**Nebraska Public Power District**

NLS2009040  
June 15, 2009

Subject: Response to Request for Additional Information for License Renewal Application  
– Aging Management Programs  
Cooper Nuclear Station, Docket No. 50-298, DPR-46

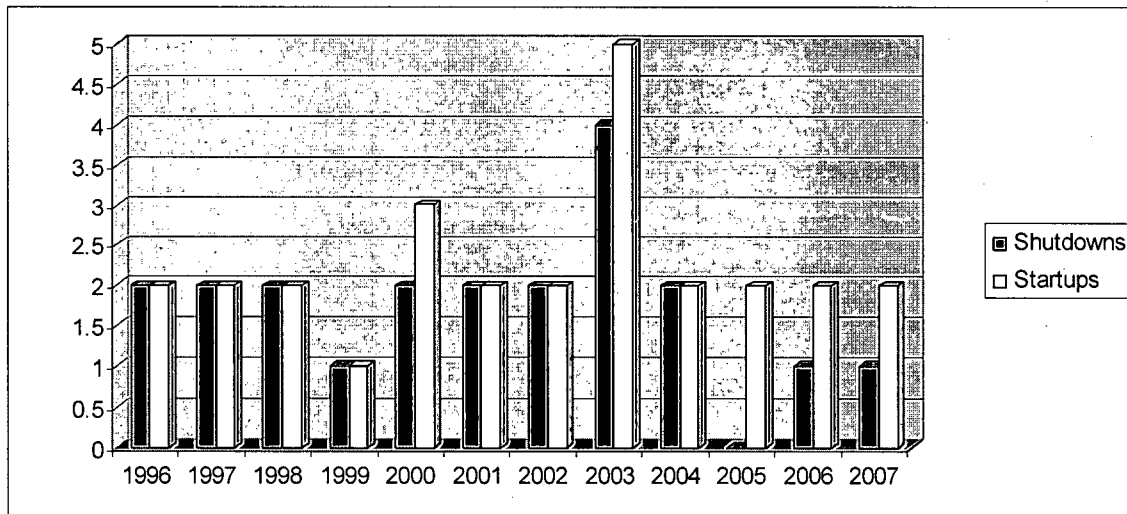
- (a) *Describe the procedures that CNS uses for tracking thermal transients.*
- (b) *Confirm that all monitored transient events are bounded by the design specifications.*
- (c) *Specify the time (years) over which actual transient monitoring and cycle tracking activities took place. If there have been periods where transient data were not recorded since the initial plant startup specify the affected time frame. For the time periods for*

*which transients were not monitored, provide justification to demonstrate that the projected cycles for this unmonitored period are conservative.*

- (d) *Provide a histogram of cycles accrued for normal start and normal shutdown transients.*
- (e) *“Background” paragraph above indicates that the CNS Fatigue Monitoring Program is based on an assumed number of cycles of transients to ensure the validity of analyses. Describe how those assumed number of cycles were established and explain why the assumed number of cycles can be used as basis to validate the Fatigue Monitoring Program.*

NPPD Response:
